SAFETY RECALL BULLETIN

NHTSA RECALL 16V720, Transport Canada 2016-497

AUTOCAR, LLC SAFETY RECALL ACX-1604 REV. 001

Autocar has determined that a safety defect exists in the steering linkage assembly of certain 2015-2017 model-year Xpeditors.

Figure 1

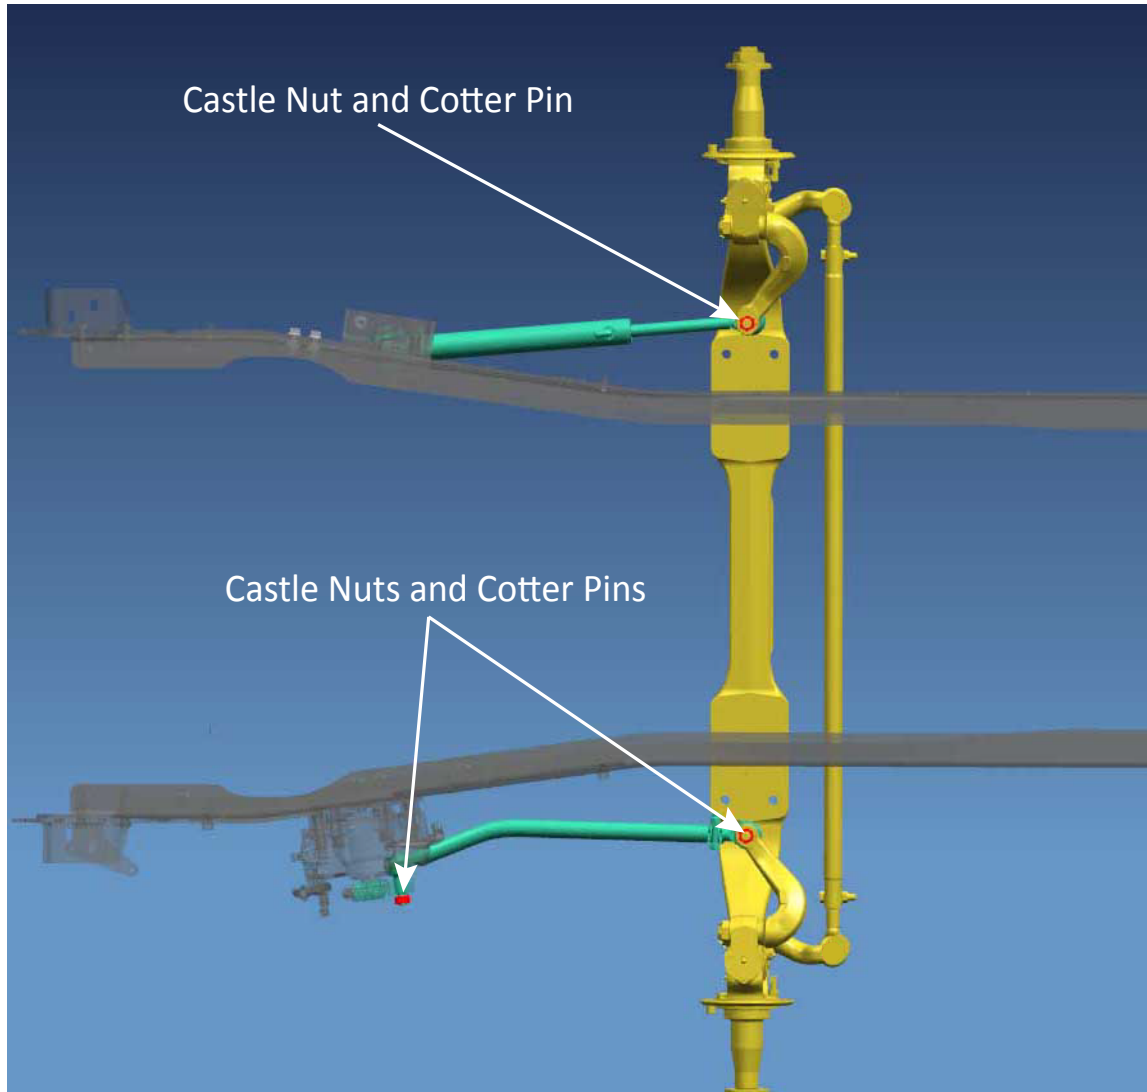
1. Raise the cab. Refer to the Safety Notices on page 2. Make sure that you read and understand the safety precautions before proceeding.
2. Locate the castle nuts on the steering components (auxiliary power steering ram, pitman arms, drag links, optional idler arms). Remove the cotter pins and discard (See Figure 1 for LH Drive or Figure 2 for RH Drive).

Figure 3

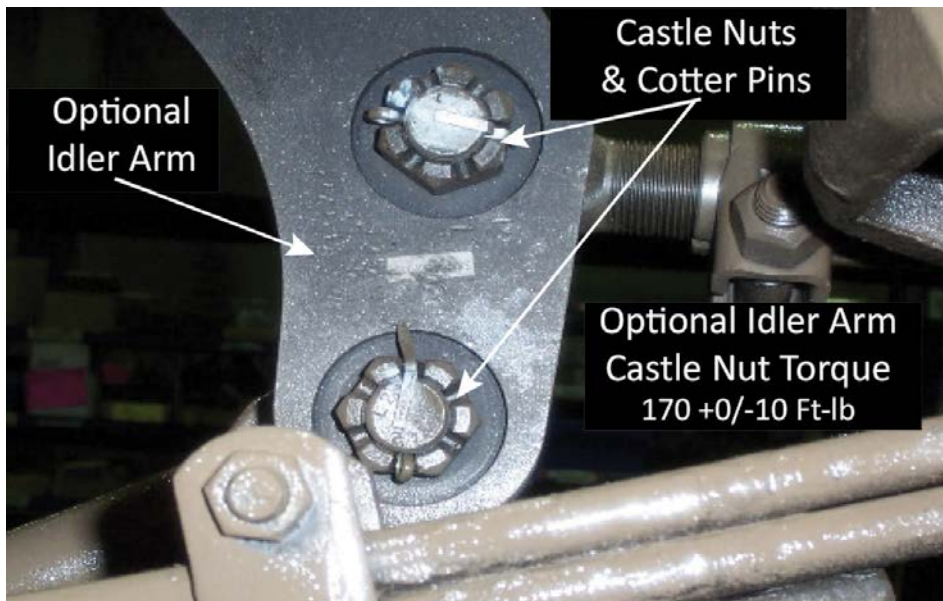
Note: Vehicles with multiple steer axles may be fitted with optional idler arms connecting drag links to each axle. Locate the castle nuts on the optional idler arm. (See Figure 3)

4. Torque each castle nut to the specified torque using the torque values shown in Figure 3 for the optional idler arm, Figure 4 for LH Drive and Figure 5 for RH Drive, and in the Torque Chart on page 8.

Figure 6

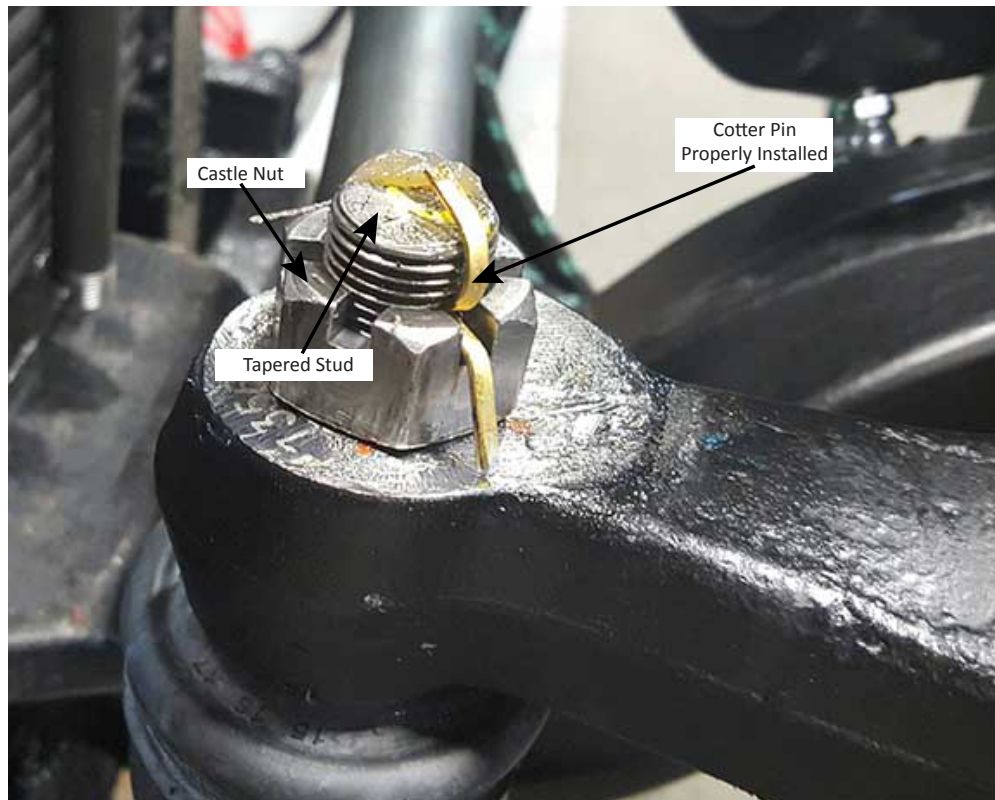
3. Un-screw the castle nut by rotating it counter-clockwise until the castle nut turns freely. Using hand force only, check for any movement of the tapered stud within the steering arm/pitman arm. Inspect each tapered stud (See Figure 6). If there are any signs wear or fretting on the contact surface between the castle nut and the steering arm/pitman arm, or if there are any signs of loose fit or movement or rotation within the steering arm or pitman arm, or if the nut will not tighten to the specified torque (See Torque Chart on page 8), call Autocar technical support at 888-218-3611.

5. Install a new cotter pin through the hole and bend one leg toward the back of the castle nut and the other up around the end of the threaded fastener (See Figure 6).
6. Repeat step 2 through step 5 until all the castle nuts in the steering assembly have been re-torqued and all of the castle nuts have new cotter pins installed.
